## Addendum # 1 Cedar Hill Bulkhead Replacement

Date of Addendum: 01/11/2019

Cedar Hill Marina  
20945 Huber View Rd  
Brydell, Md. 21814

Slips 122-135

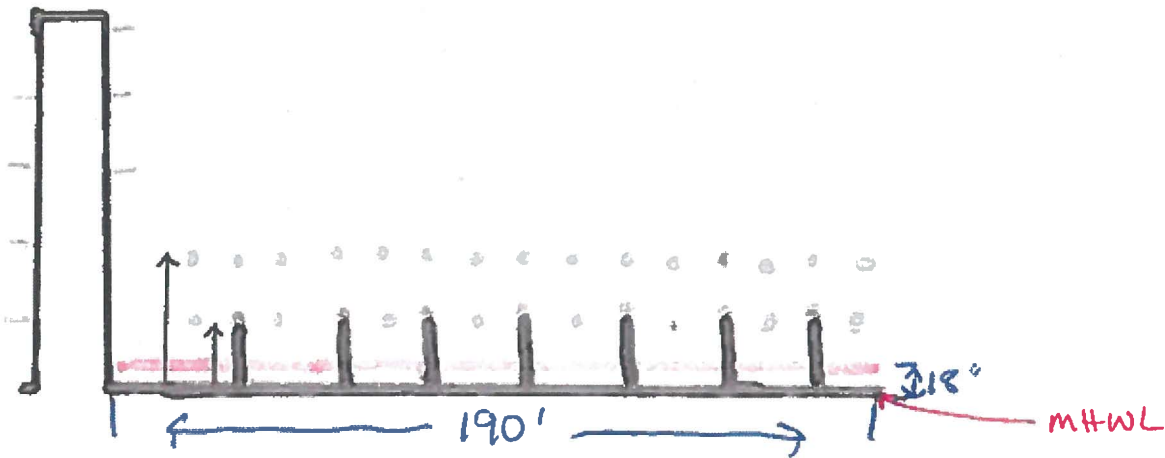
2.2	<p>Q. Please provide or direct us to an overall site drawing indicating the limits of the bulkhead replacement and the finger piers to be replaced.            A. <b>See diagram</b></p>

2.10	<p>Q. Can the Engineer provide a count or quantify the number of piles to be replaced for bidding purposes.</p> <p>A. <b>See diagram</b></p>
2.11	<p>Q. Can the Engineer provide a count or quantify the type of each pile to be replaced for bidding purposes. For example, bulkhead, deadman, mooring, pier.</p> <p>A. <b>See diagram</b></p>

1901 of replacement  
bulkhead in  
area of slips 122-135

Replace finger piers  
and 30 mooring piles

All new features to move 18" channelward
